Technical Service Bulletin

92 Rattle from instrument panel area

92 13 07 2021833/5 March 4, 2013. Supersedes Technical Service Bulletin Group 92 number 13-06 dated February 1, 2013 for reasons listed below.

Figure 2. Area to attach the foam pad.

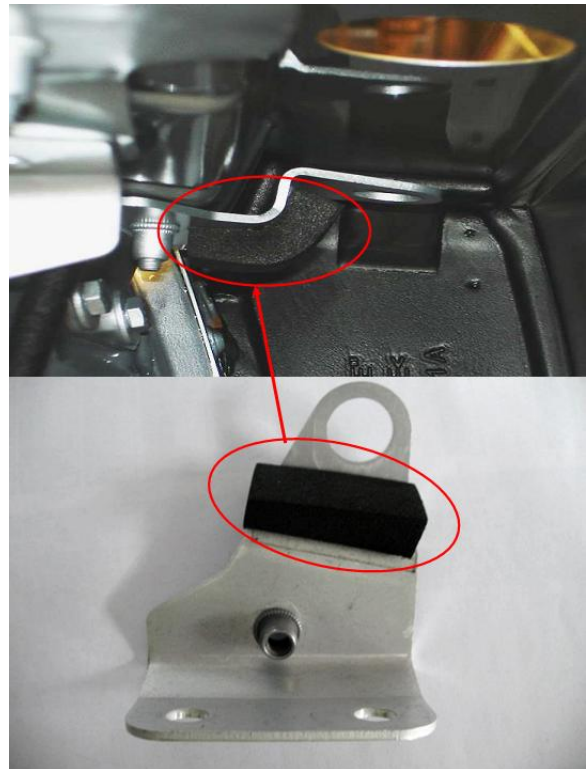
Excessive free play between the mounting bracket for the windshield washer reservoir and the washer reservoir (Figure 1).

1. Remove the front wheel housing liner.
2. Check the windshield washer reservoir for free play in the mounting bracket.
If there is free play in the mounting bracket, attach the self-adhesive foam pad **8E5868739** on the mounting bracket as shown in the illustration (Figure 2).
